REQUEST FOR INFORMATION	DATE: July 22, 2016	NO.: RFI-214
--------------------------------	----------------------------	---------------------

Project Name: 15051-Webster University Interdisciplinary Science Building	Project No.: 15051
---	--------------------

Subject: Fall Protection Design

SHEET NO.
2.01

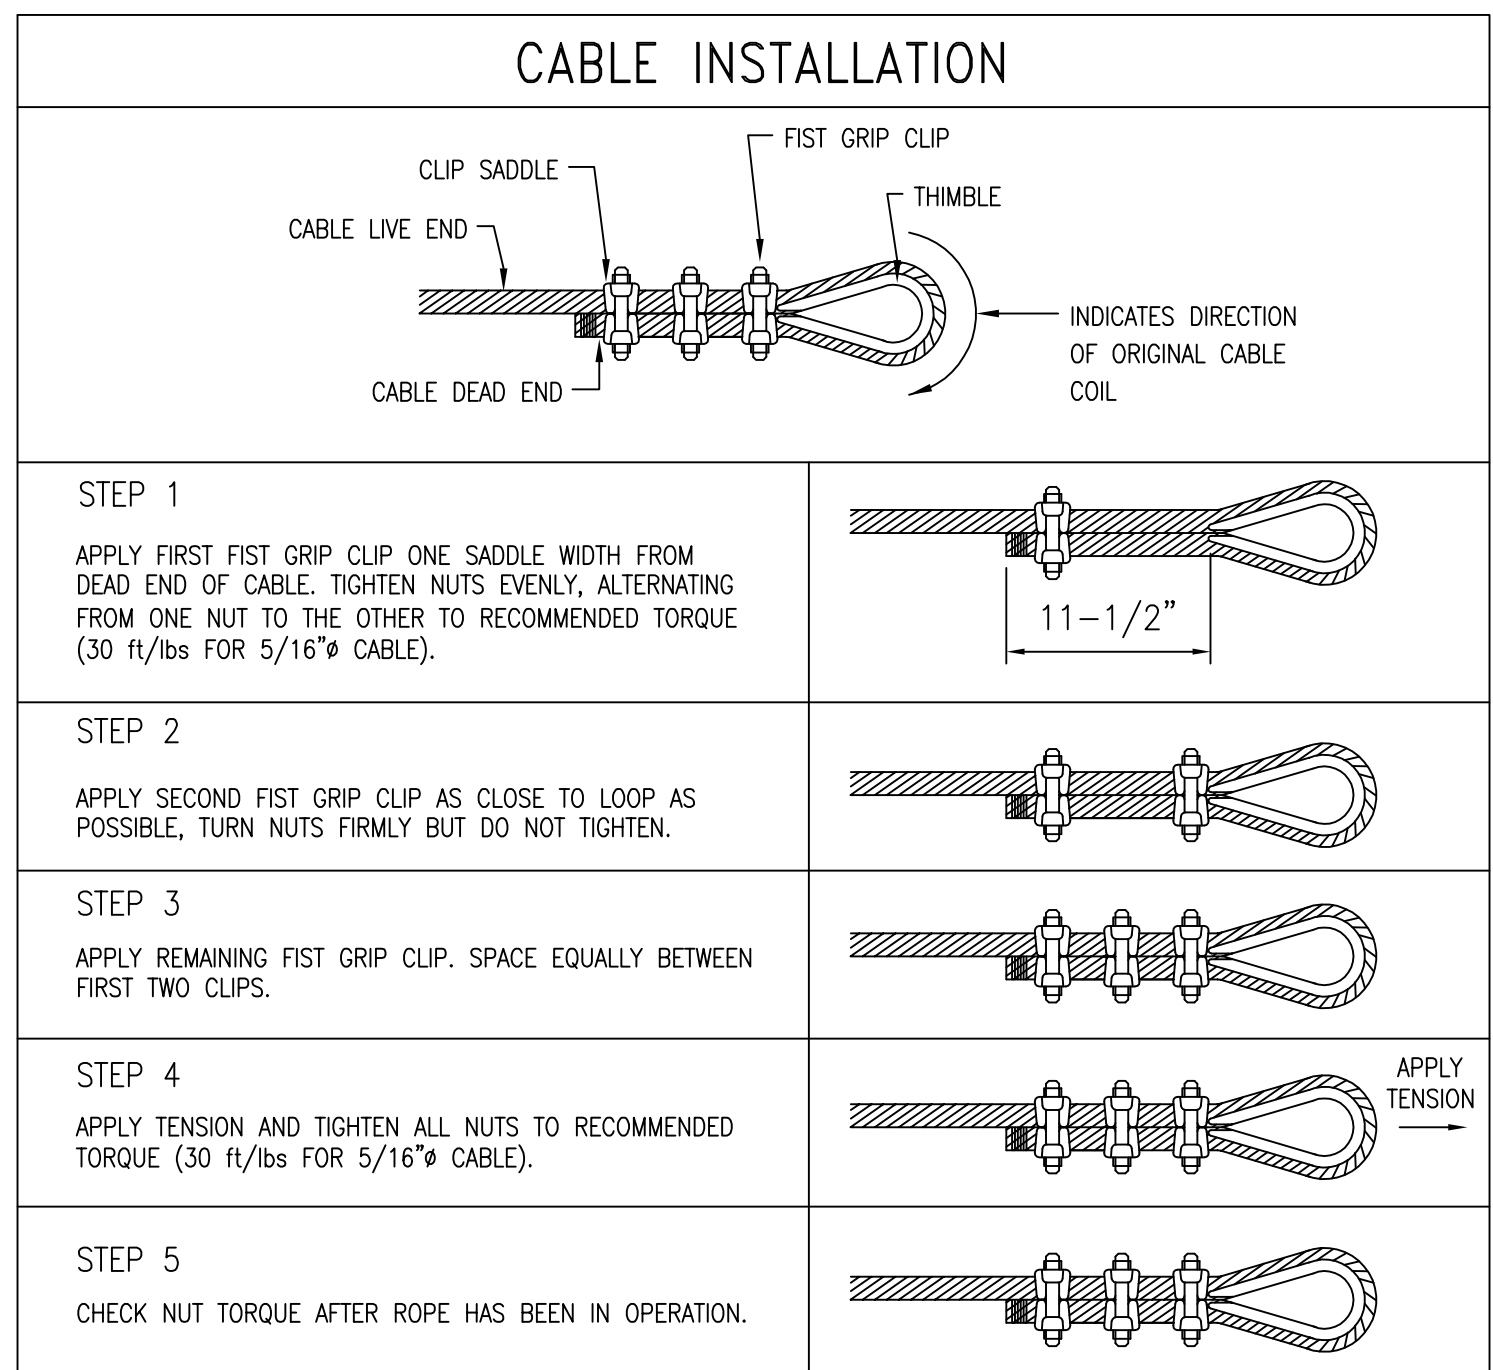
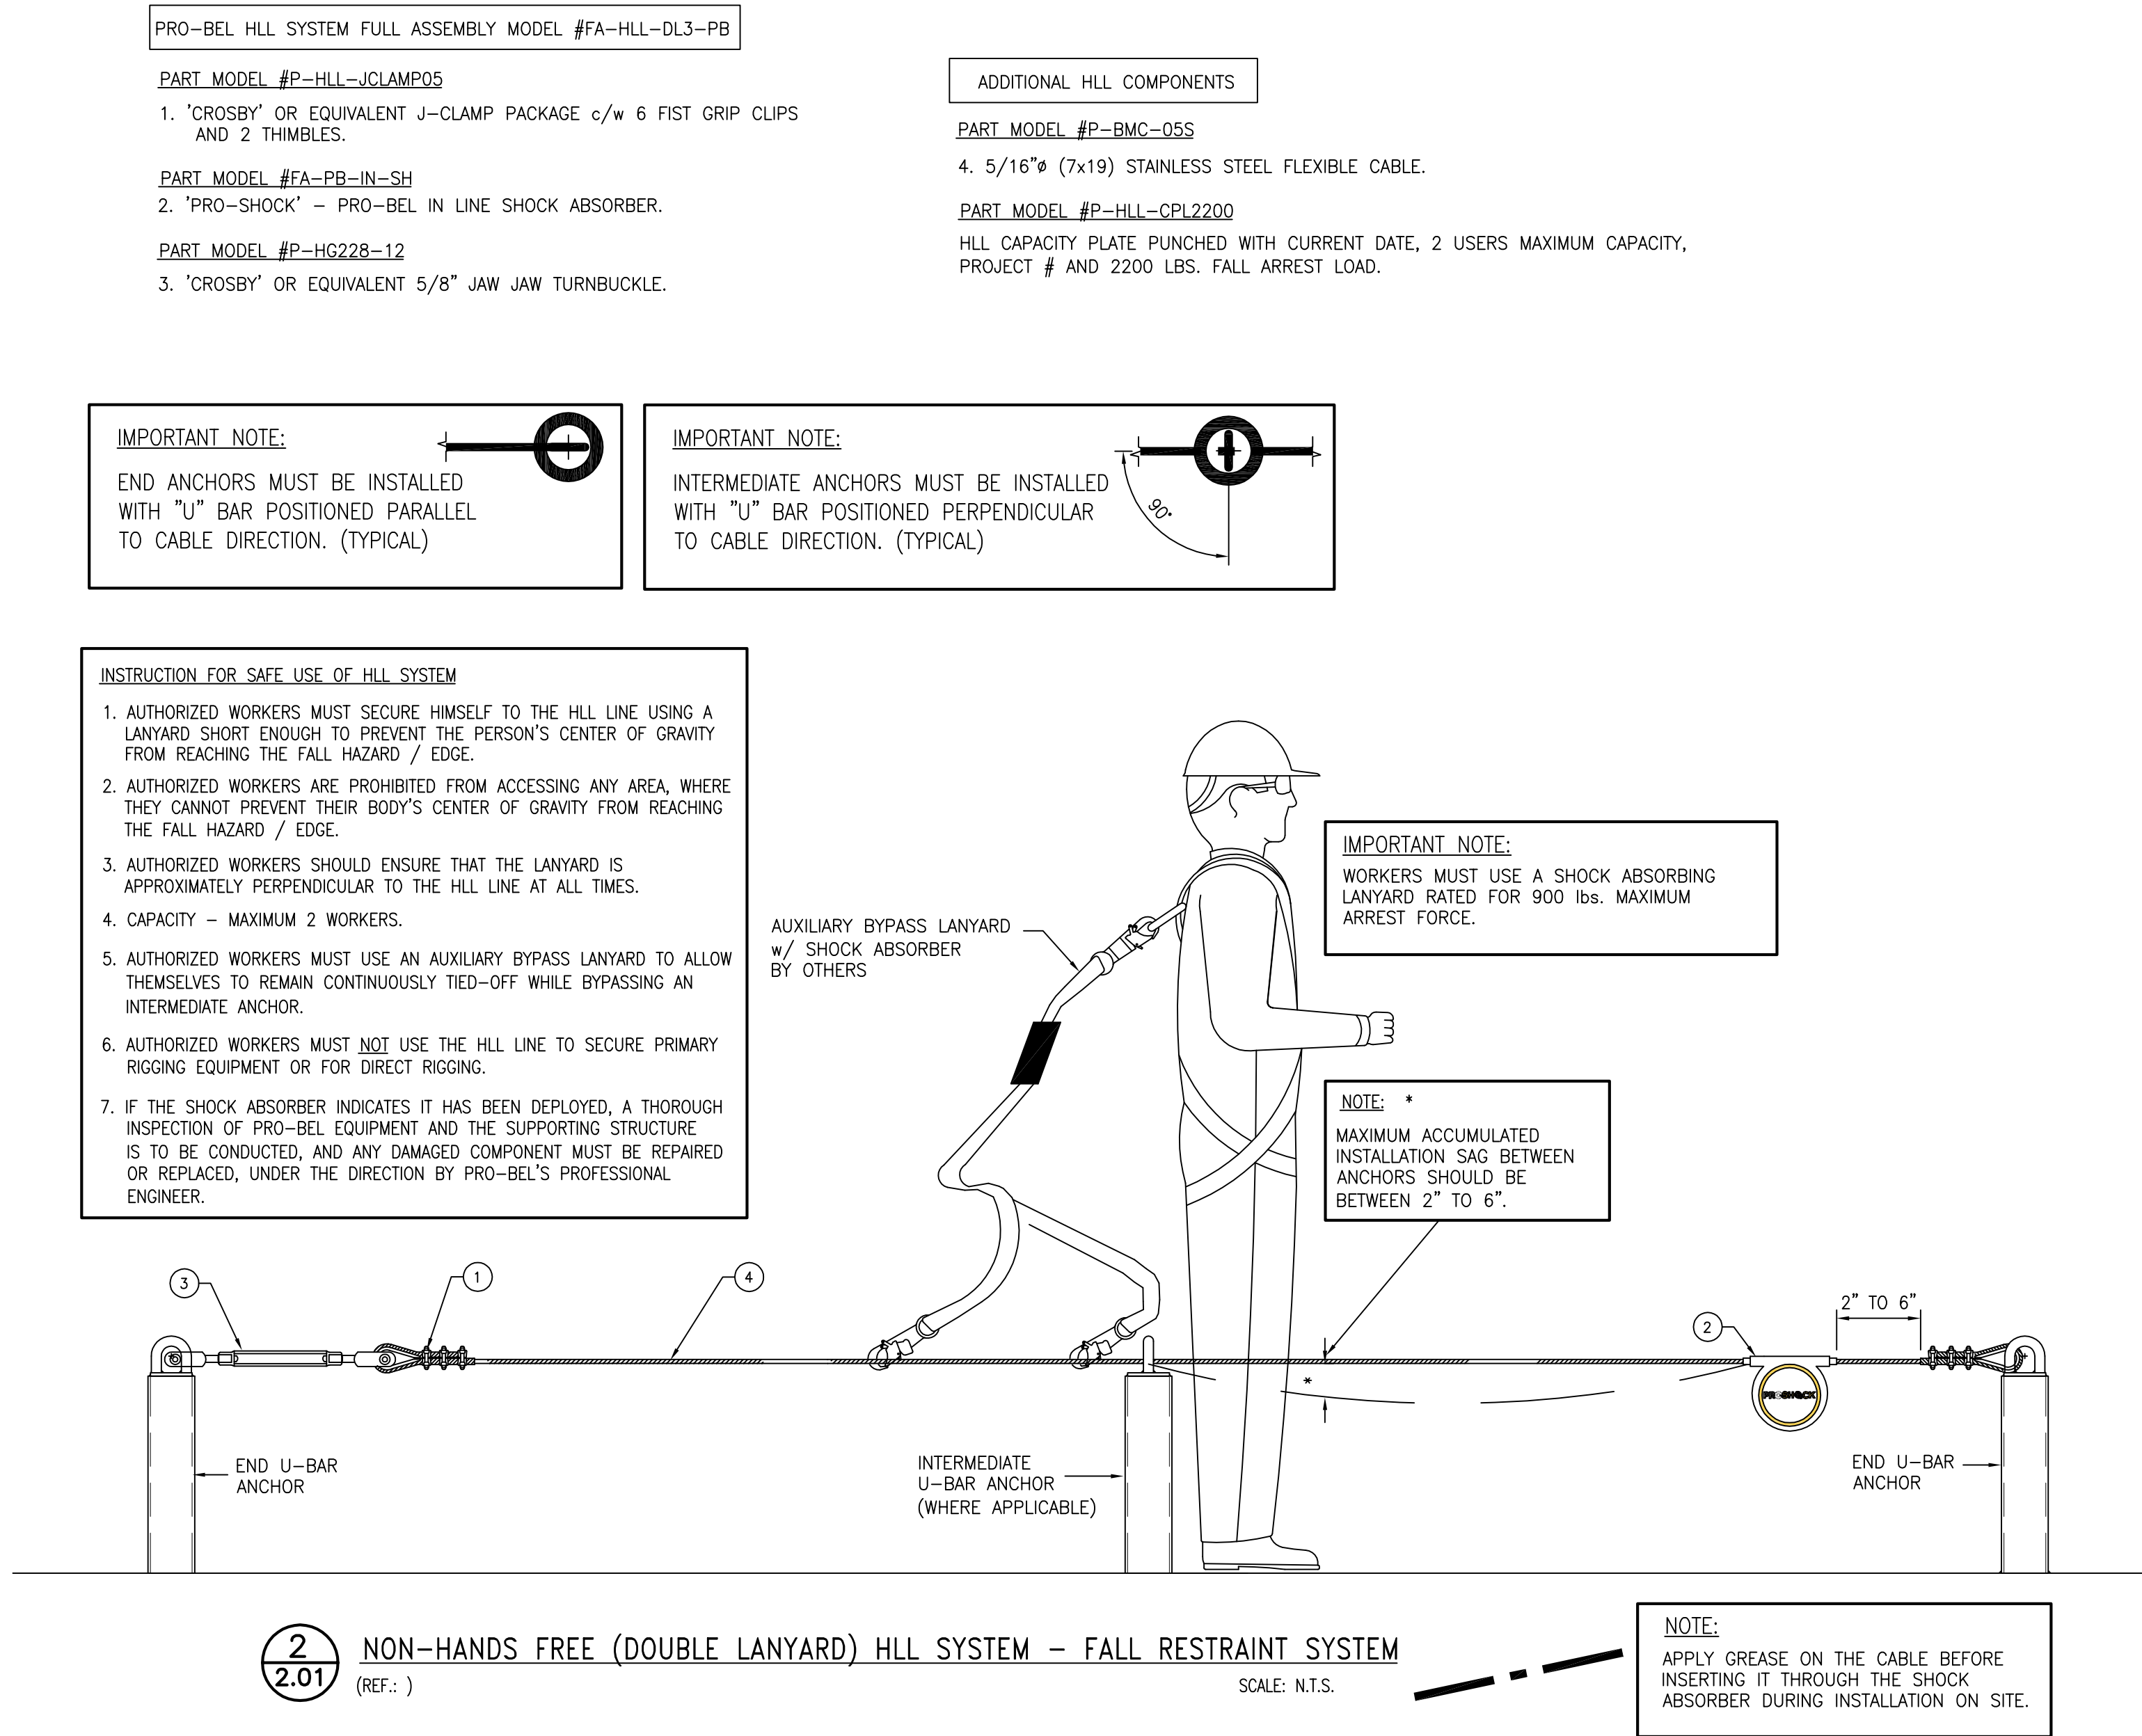
Probel originally submitted their drawings based on the architectural layout, and used that layout to indicate which two anchors they wanted/needed to relocate so that they could take responsibility of the fall protection system. Since this would require relocating the 12x6 tubes the anchors are attached to; Atlas feels the design team should review and approve the change. If this is an acceptable change, then Atlas expects Probel to re-issue drawings for approval based on the structural layout (per RFI 188), adding the (3) anchors and the +/-25' of cable.

Not in KWA's scope of work. Specification Section 110140, paragraph 1.7 A, fall protection design shall be delegated.
